SB-05-06-19-1

SkyView sensor configuration

MODEL- Ranger R7 **SERIAL NO:** 10131, 10132, 10133, 10134, 10135, 10136, 10137, 10138, 10139, 10140, 10141, 10142, 10143, 10144, 10145

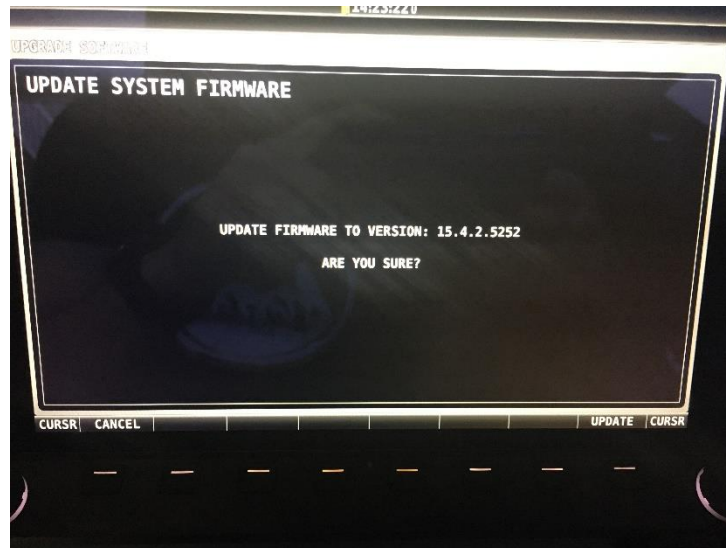
The fuel pressure sensor in the SkyView configuration settings was set as a 50 PSI sensor instead of the installed 15 PSI sensor.

- B. Turn Master, Avionics, and Autopilot switches ON
- C. Enter setup menu on SkyView (Press and Hold buttons 7 & 8)
- D. Select 'SYSTEM SOFTWARE'
- E. Select "UPGRADE SYSTEM SOFTWARE TO 15.4.2.5252"
